KBSO Project #: 24023
Project Name: Noblesville HS AHU Replacements – Bid Pack 2
Issue Date: 10/10/2024

This Addendum number 1 to the drawings and specifications shall supplement, amend, and become a part of the bidding documents, plans, and specifications. All bids and construction contracts shall be based on these modifications to the original contract documents.

2 AHU-18 DEMO SECTION
1/4" = 1'-0"

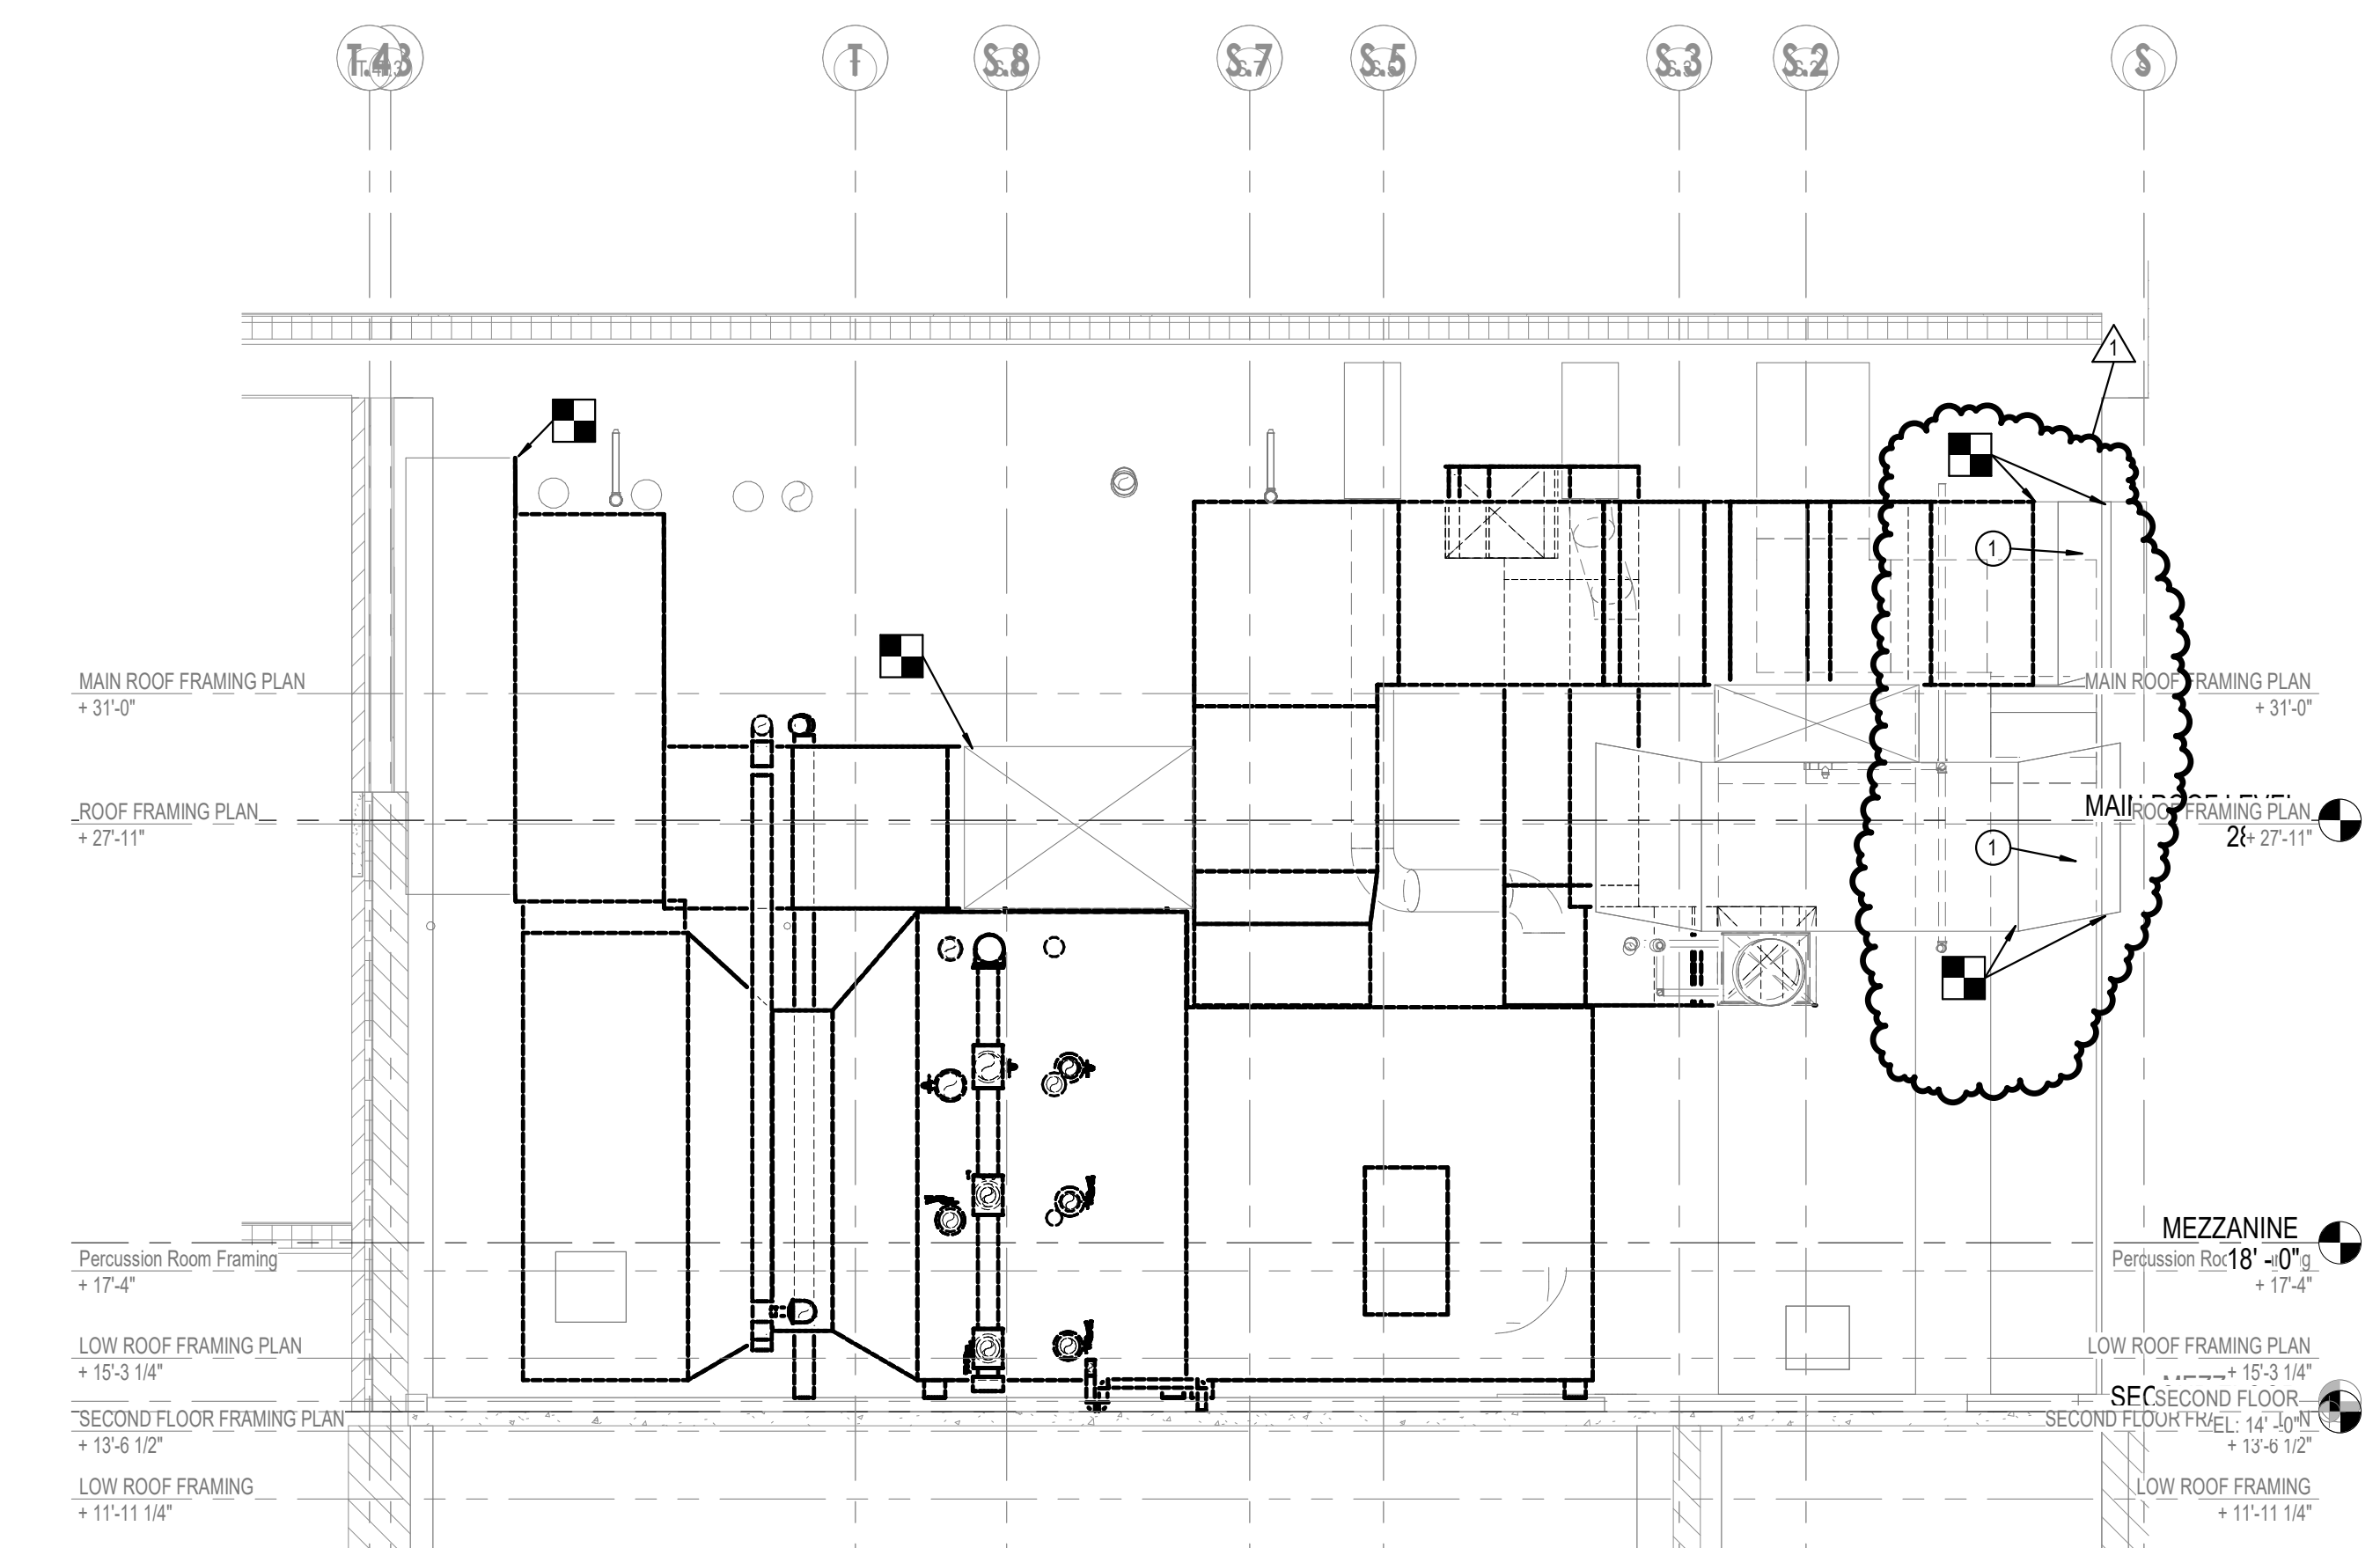
- 3.01 M521 - MECHANICAL DETAILS
 - a. See revised drawings with revision clouds included
- 3.02 M621 - MECHANICAL SCHEDULES
 - a. See revised drawings with revision clouds included
- 3.03 M721 - GROUND FLOOR CONTROLS & LOGISTICS PLAN
 - a. See revised drawings with revision clouds included
- 3.04 M722 - SECOND FLOOR CONTROLS & LOGISTICS PLAN
 - a. See revised drawings with revision clouds included
- 3.05 MD321 - MECH RM M11 MECHANICAL DEMOLITION PLAN
 - a. See revised drawings with revision clouds included
- 3.06 MD322 - MECH RM M12 MECHANICAL DEMOLITION PLAN
 - a. See revised drawings with revision clouds included
